**California State University San Marcos
Mangrum Track Lighting and Cell Tower Project**

Final Initial Study/Mitigated Negative Declaration

State Clearinghouse No. 2014041053

July 2014

Figure 6a

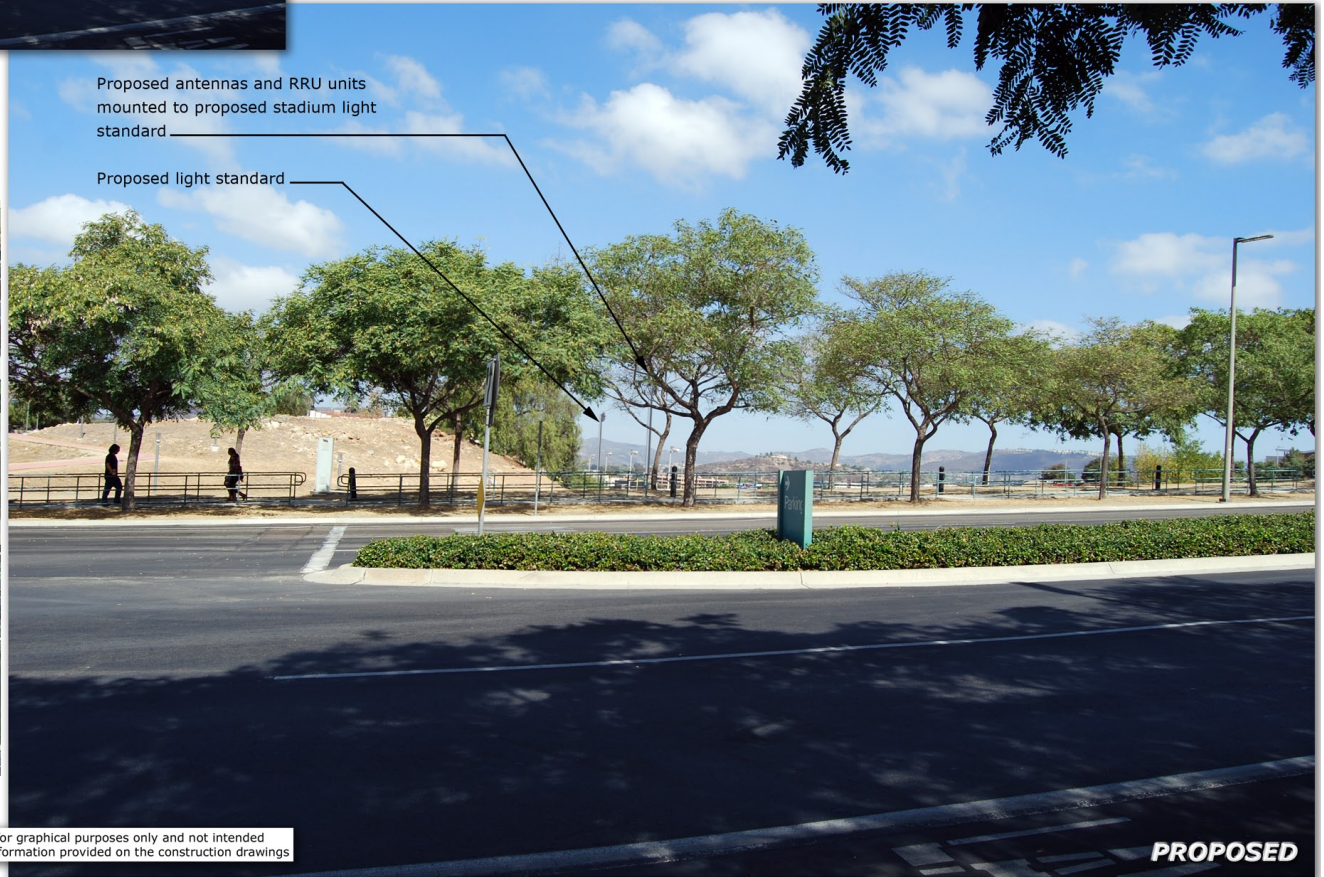
D-3 The reference to color and form, discounts the visual impact of the antennas themselves on the 119 foot high pole, which would be clearly visible from Craven Road, as demonstrated in Figure 6b. This visual impact does require mitigation.

D-3 This comment states that the visual impact of the project, as visible from Craven Road, would require mitigation. The cited figure, Figure 6b, is a simulation from the trail adjacent to the track, not from Craven Road. The trail sits at a lower elevation than Craven Road, views from which are better depicted in Figure 6c. As shown in Figure 6c, a northeasterly view from eastbound Craven Road, the rise in elevation and intervening vegetation between the Mangrum Track and Craven Road would mostly shield the proposed light standards and cell tower from view. The proposed project features would not be a dominant visual feature within this viewpoint, and would be smaller in scale than other liner elements in the foreground (e.g., the existing streetlight and stop sign). Accordingly, visual impacts from Craven Road would be less than significant and no mitigation would be required.
